SUBJECT: Forwards Rev 1 to EWR 5327, "Design Verification Ginna StatioContainment Foundation Mat Analysis," in response to 910625 request for addl info re containment integrity.

Subject: Ginna Containment Integrity
Request for Additional Information
R.E. Ginna Nuclear Power Plant
Docket No. 50-244 (TAC No. 80494)

FIGURE 1

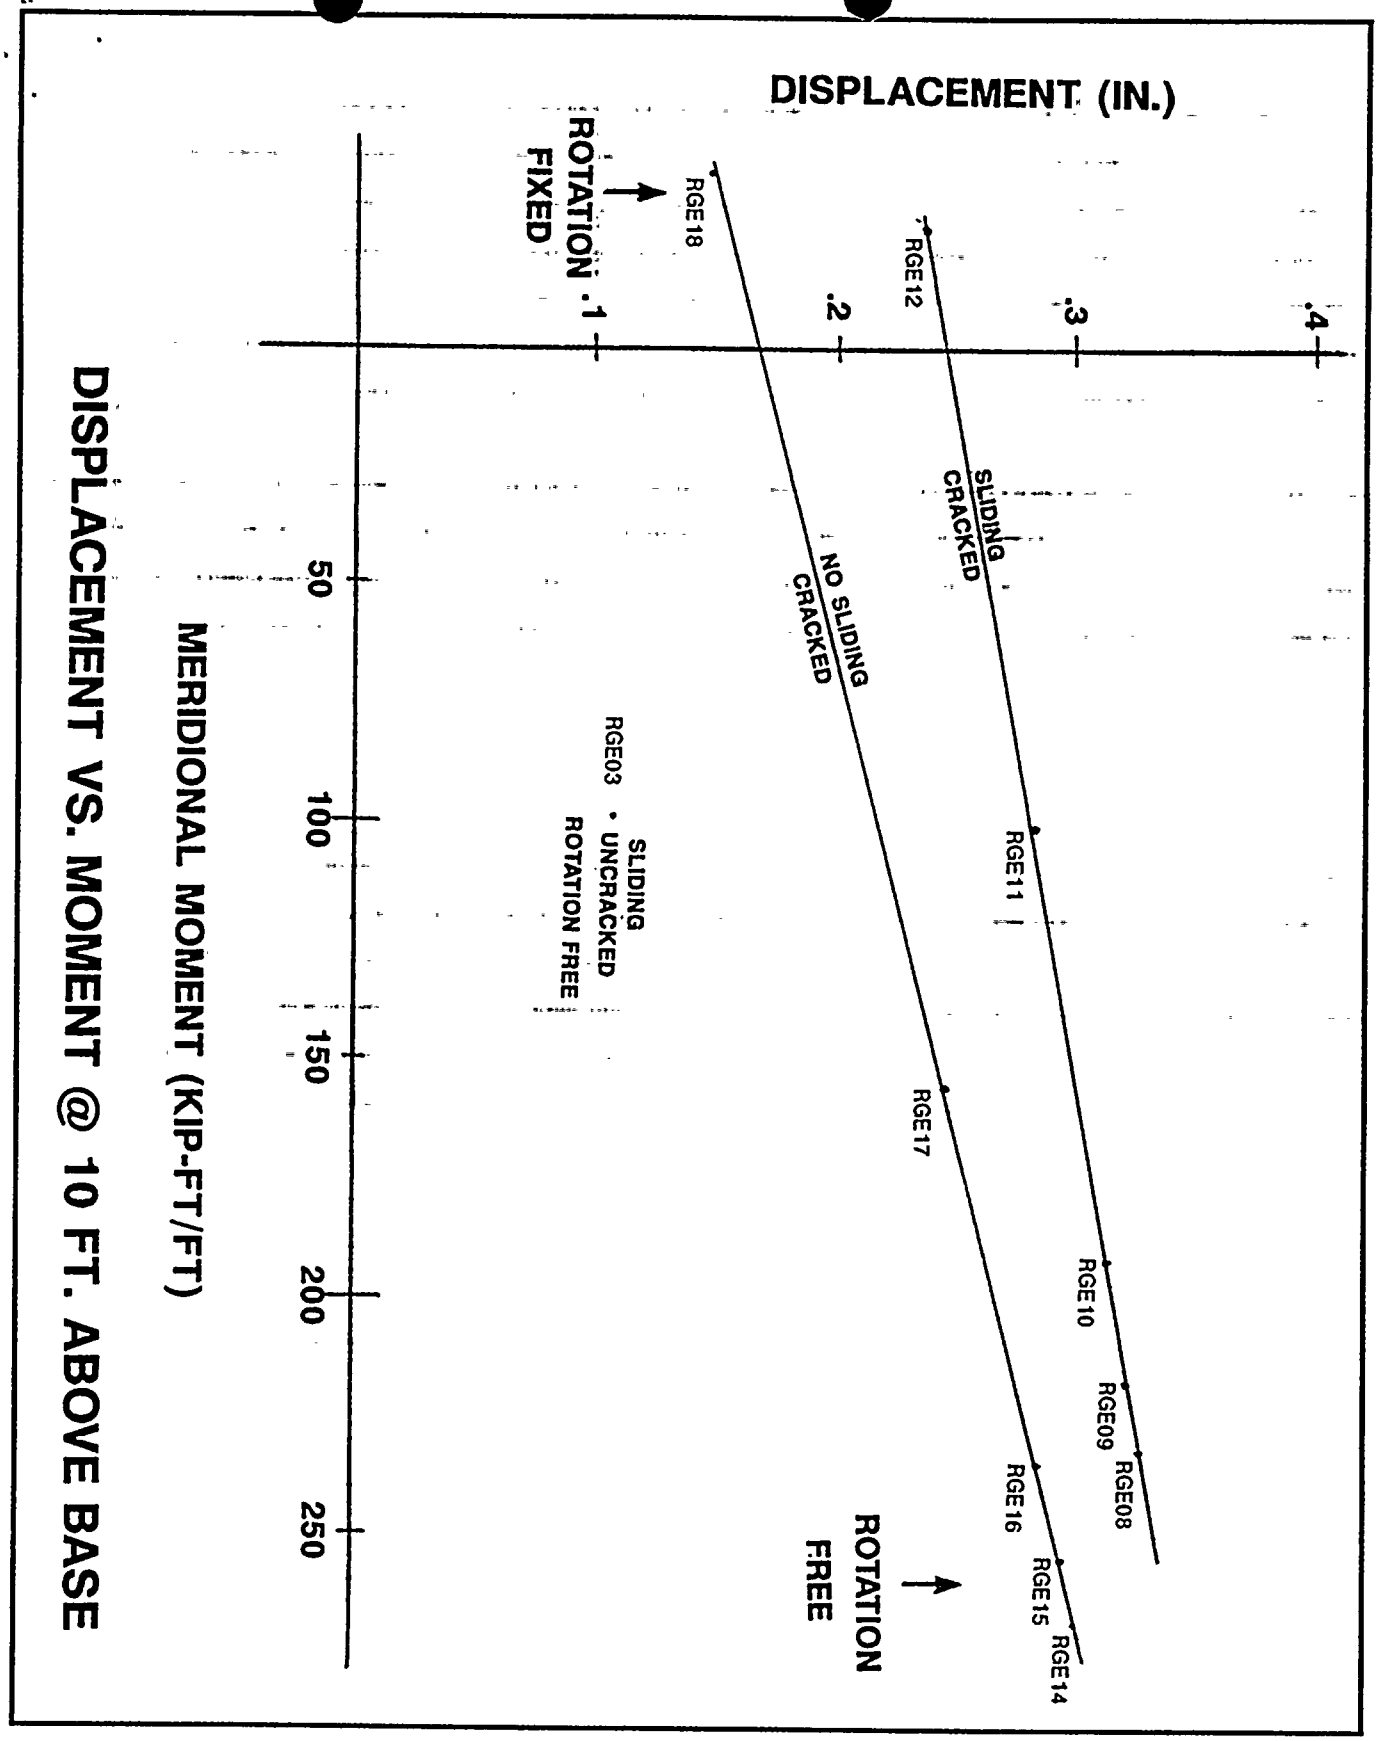
Figure 1 is a graph of radial displacements vs moment for the full range of base rotational resistance due to internal pressure. They demonstrate the response of the structure for the sliding and non-sliding boundary conditions. As can be seen, the upper bound for both deflection and moment is at the pinned condition, and decreases as rotational resistance increases.

FIGURE 2

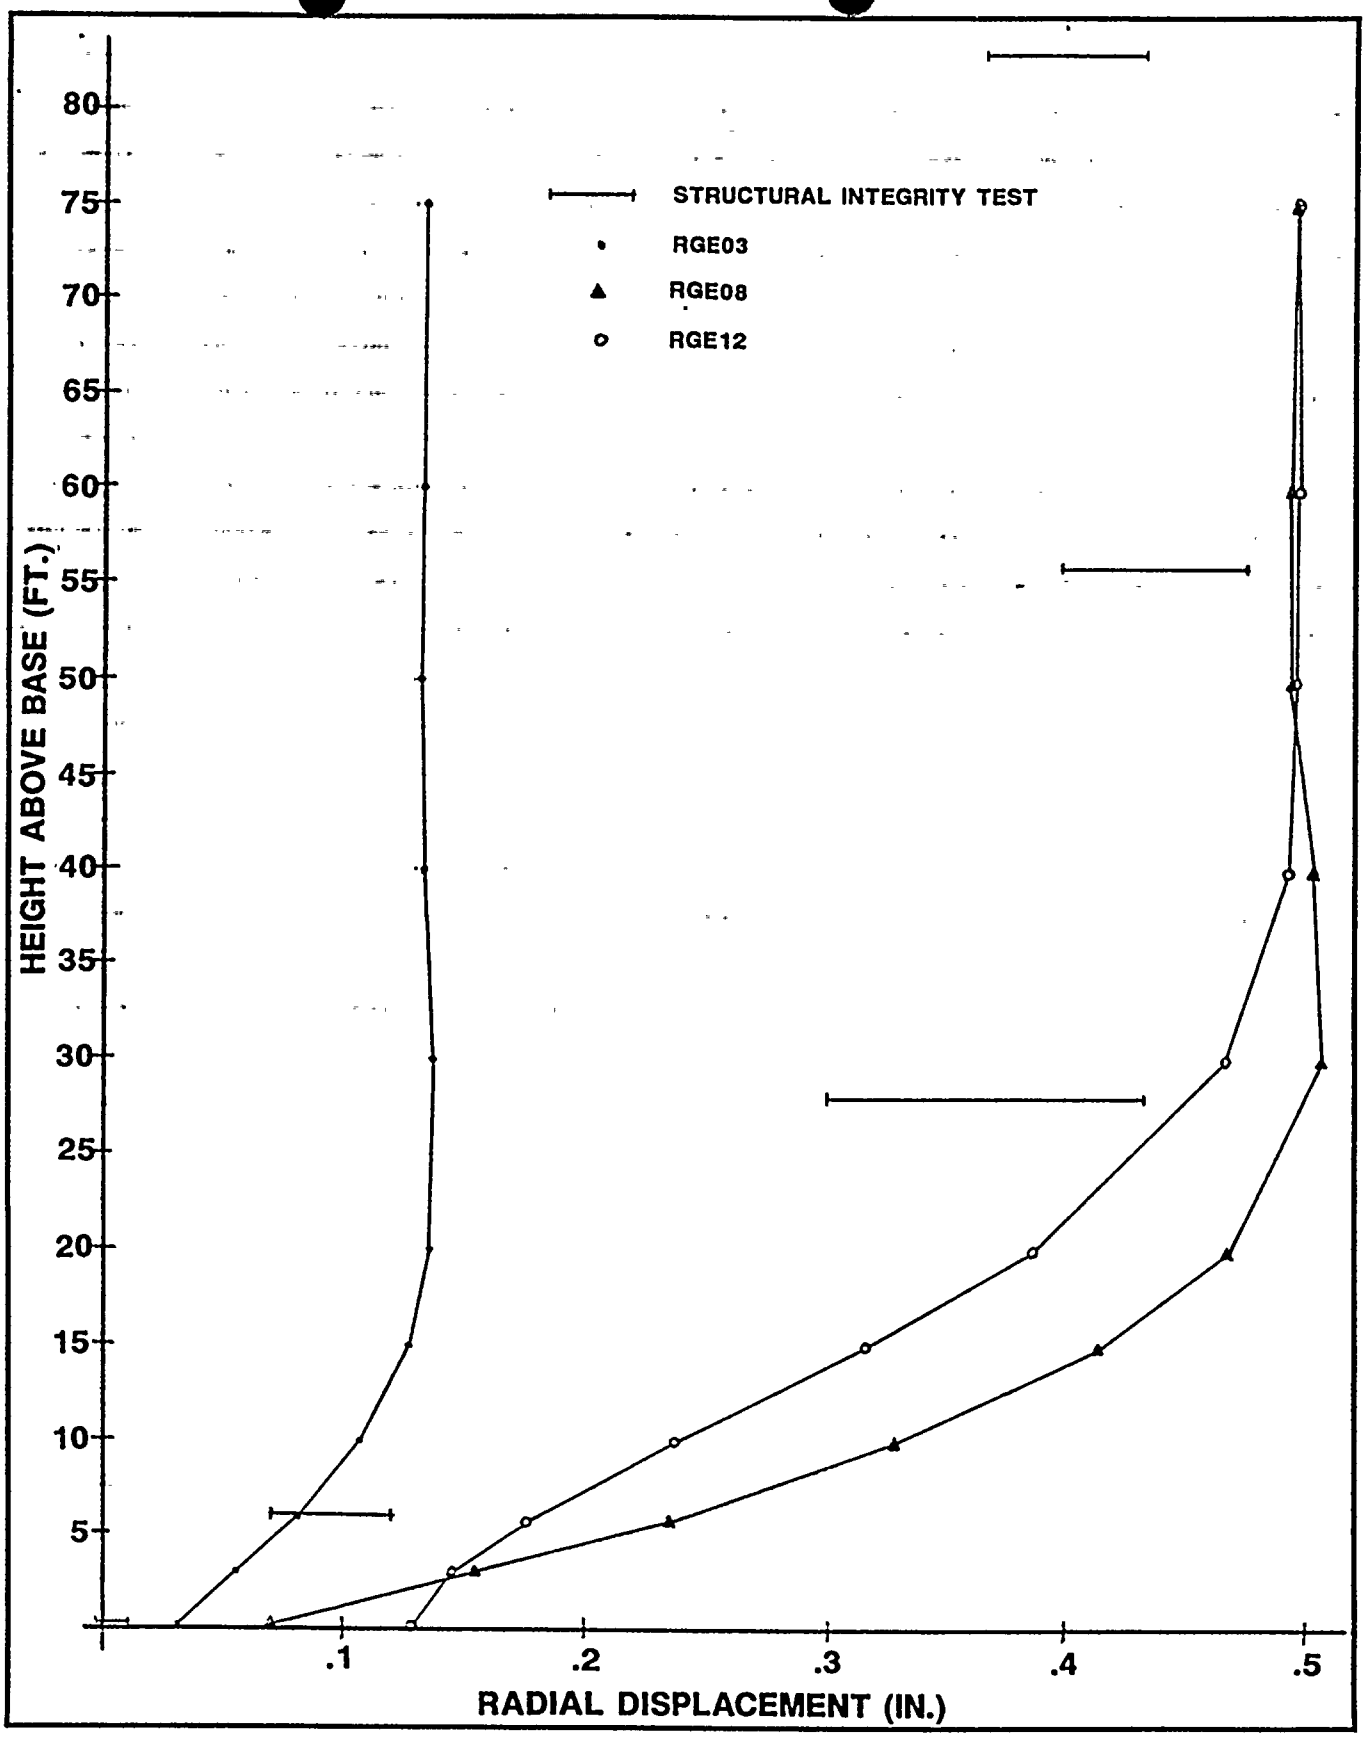
In the above comparisons where the capacity falls short of the demand induced by the appropriate load combination, provide the necessary justification for assuring containment integrity and propose what physical evidence can be obtained about the true base condition during an integrated leak rate test.

Figures 2 is a plot of radial displacements of the containment for RGE08 (pinned), RGE12 (fixed), and the results of the original Structural Integrity Test (SIT). Also shown are the displacements

for RGE03. RGE03 is the lower bound for displacements because it was run with the hoop stiffness assumed to be based on an uncracked concrete section. RGE08 and RGE12 are predictably higher than this case since these analyses were done with the hoop stiffness based on the reinforcing steel alone, which is orders of magnitude less than an uncracked section. As expected, the SIT results are between these values because the actual stiffness at the test condition, is a combination of cracked and uncracked sections.

The graph, Figure 2, displays the expected behavior of three models in relation to the SIT results. RGE03 (pinned, sliding base, uncracked concrete) matches fairly closely the SIT results near the base where you would not expect much cracking due to the presence of the radial tension bars. At higher elevations, RGE03 understates the displacements because there is cracking. The results of RGE09 (pinned, sliding base, cracked concrete) and RGE12 (fixed sliding base, cracked concrete), overstate the displacements

at all locations, as expected, but are closer to the SIT values at higher elevations.
